Access Compliance Report

Public Rights-of-Way

(Curb Ramps)

Intersection ID: 10181	Main Street: BACON_AV	Cross Street: ROSLYN_AV	Location: W
ADA ID: 6D5886D3F027	Ramp Type: PerpDiag	Initial Pass/Fail: Fail	Overall Compliance: No
Severity Score: 47.5			
Codes/Mitigation Info/Possible Solution		Field Measurements/Component Compliance

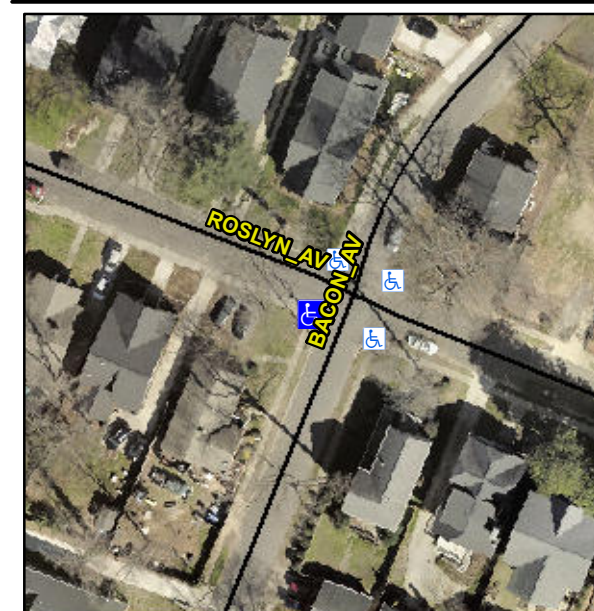
Not Found, R304.5.1, R304.2.2

Compliance	Description	Data	Compliance	Description	Data
N/A	Ramp Length (in)	45.0	No	Ramp Slope (%)	10.1
No	Ramp Width (in)	31.0	Yes	Ramp XSlope (%)	0.7
N/A	Flare Type LT	N/A	N/A	Flare Type RT	N/A
N/A	Flare Slope LT (%)	N/A	N/A	Flare Slope RT (%)	N/A
N/A	Flare Traversable LT?	N/A	N/A	Flare Traversable RT?	N/A
N/A	Landing Length (in)	N/A	N/A	DWS Provided?	N/A
N/A	Landing Width (in)	N/A	N/A	DWS Contrast?	N/A
N/A	Landing Slope (%)	N/A	N/A	DWS Length (in)	N/A
N/A	Landing X Slope (%)	N/A	N/A	DWS Full Width?	N/A
N/A	Landing Curb? (Y/N)	N/A	N/A	DWS Offset (in)	N/A
N/A	Shared Landing?	N/A			
N/A	Gutter Ponding?	Yes	N/A	Gutter Slope (%)	N/A
N/A	Gutter Lip Ht (in)	N/A	N/A	Gutter X Slope (%)	N/A
N/A	Painted X Walk1?	No	N/A	Painted X Walk2?	No
	X Walk 1 Direction	To SE		X Walk 2 Direction	To NE
N/A	X Walk 1 Width (in)	N/A	N/A	X Walk 2 Width (in)	N/A
	X Walk 1 Slope (%)	6.0		X Walk 2 Slope (%)	7.7
	X Walk 1 X Slope (%)	3.9		X Walk 2 X Slope (%)	2.0

Remove & Replace Curb Ramp With Two New Directional Ramps or Equivalent.
